**FRIENDS
OF THE
RIVER**

April 29, 2005

Re: Comments on Battle Creek Restoration Project SEIS/REIR

Inskip Reach, Battle Creek, Jun-Sep

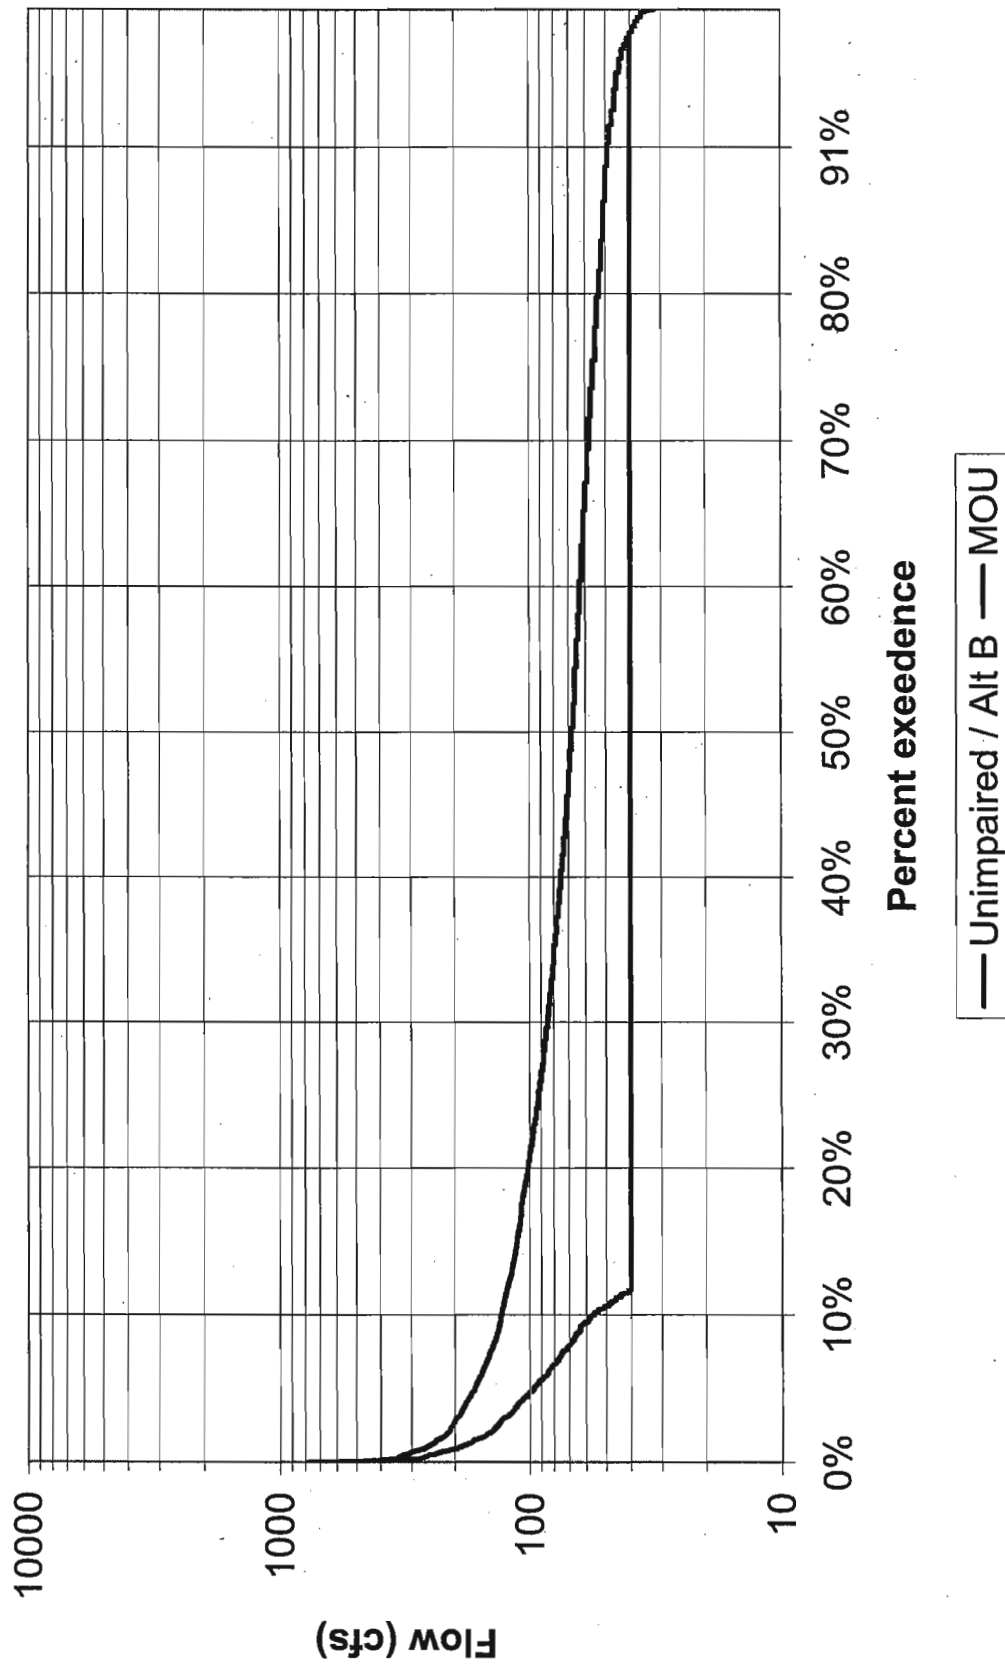
- **Duration.** Clear differences in the duration of flows are illustrated in Figures E-1 to E-6, comparative flow exceedence curves for the mainstem, Eagle Canyon, and Inskip reaches. For example, if flows below 50 cfs were found to form a natural barrier in Eagle Canyon, Figure E-5 shows MOU flows would exceed that amount in summer 20% of the time (24 days), based on the 1962-2002 period of record. Alt B flows would exceed 50 cfs 97% of the time (118 days).
